Preservation Department – Item 1, LPC-26-12659

257 Canal Street – SoHo-Cast Iron Historic District Extension
Borough of Manhattan

NYC LANDMARKS PRESERVATION COMMISSION
LPC PUBLIC MEETING

SEPTEMBER 15, 2026

BUILDING BASE

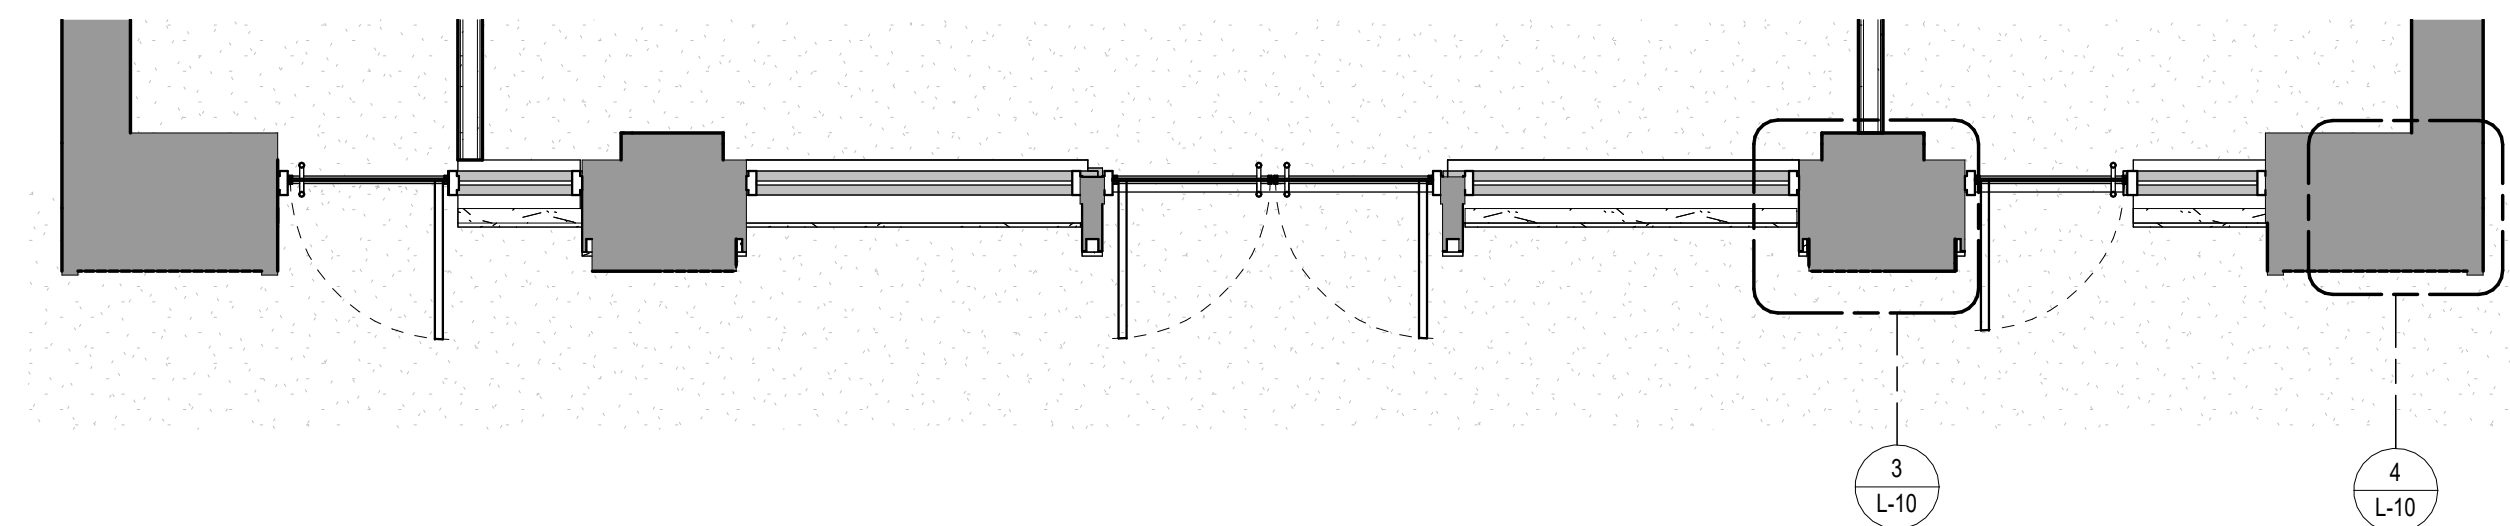
- GIVE THE BASE GREATER PRESENCE THROUGH ADDITIONAL HEIGHT AND ARTICULATION
- CONSIDER REDUCING FLR-TO-FLR HEIGHTS AND ADJUSTING THE PROPORTION OF THE WINDOWS
- RESTUDY THE MANSARD'S FENESTRATION AND DETAILING
- CHANGE THE BRICK SELECTION TO A WARMER TONE CLOSER TO THE BUFF, LIMESTONE PALETTE SEEN IN THE HISTORIC DISTRICT

- FLR-TO-FLR HEIGHTS AT FIRST AND SECOND FLOORS INCREASED, AND ADDITIONAL ARTICULATION AND DETAILING ADDED TO THE BASE
- REDUCED FLR-TO-FLR HEIGHTS BY 8" RESULTING IN ADJUSTED WINDOW PROPORTIONS AND A 4' REDUCTION IN OVERALL BUILDING HEIGHT
- MANSARD DETAILING ADJUSTED AND DORMER WINDOWS REDESIGNED
- NEW BRICK BLEND SELECTED USING BUFF PALETTE MORE CLOSELY MATCHING THE TONE OF THE DISTRICT'S PREDOMINANT MATERIAL PALETTE
